June 20, 2018

# SUBJECT: ProAct Digital Plus Product Line Statement

Figure 1. Early Prototype of ProAct Gen3 Product Line

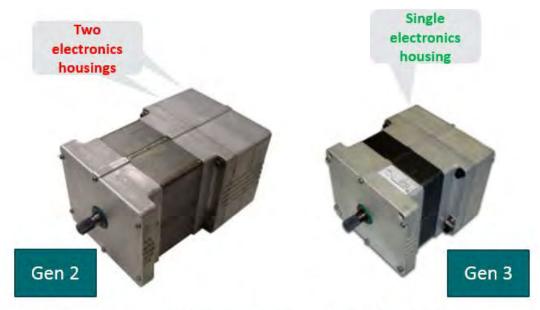
Although the ProAct Digital Plus product lines have reached end of life, Woodward has planned to release the next generation of ProAct Gen3 Digital Plus (Flex) which would be backward compatible and meet ROHS, REACH, and marine compliance. The ProAct Gen3 Digital Plus product line will offer a more accurate and less noisy position sensor, and hosts a much more powerful process core capable of implementing latest software requirements. See Figure 1 for additional information on the Gen3.

Features	ProAct Gen2 Digital Plus	ProAct Gen3 Platform
ROHS	No	Yes
Marine	Yes – only Digital Plus	Yes – all ProAct variants
Position Accuracy	<+/- 1.0% of full stroke at 25 °C after calibration and +/- 1.5% linearity	<+/- 1% of full stroke over -40 °C to 85 °C and +/- 1.5% linearity across temperature
Communication	Serial (RS 232) with one CAN	Two CAN
Discrete Input	Same	Same
Discrete Output	High side	Both low side and high side (software configurable)
Analog Input	Same	Same
Analog Output	4 to 20 mA	4 to 20 mA and 0-5V (external and software configurable)
PWM Command Input	Push Pull only	SW configurable between push pull or low side; two thresholds available – customer configurable. 0-5V or 0-12V
Power Consumption	Same	Same
Operating Parameters		Will match ProAct Gen2 version. Modifications available upon request
